Service Bulletin

Front Corner Weld Reinforcement on Fiberlite POD and POD XL Replaceable Tongue Frame

Inspection Location – Bottom View

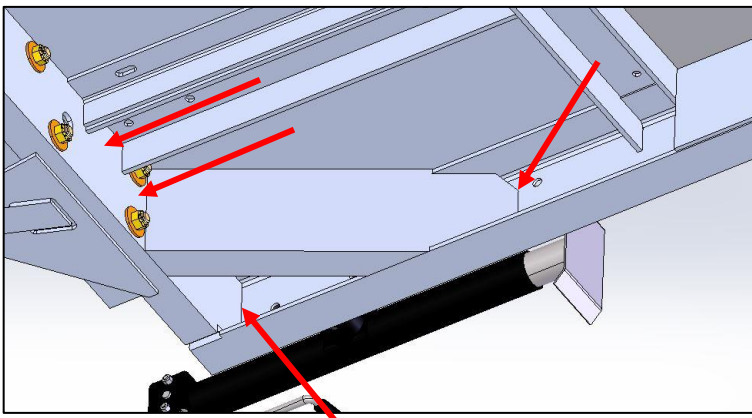
Inspect the welds between the frame rails and front cross-member. Picture below shows a representative trailer with the impacted areas circled in red.

In order to fully inspect the affected areas, the inspector must view the frame from underneath. The representative image below is a view of the front curbside corner of the frame weldment from underneath the trailer. The red arrows point to the specific weld joints to closely inspect for any cracks in or around the welds. Be sure to check the weld joints on both the street side and curbside of the trailer.
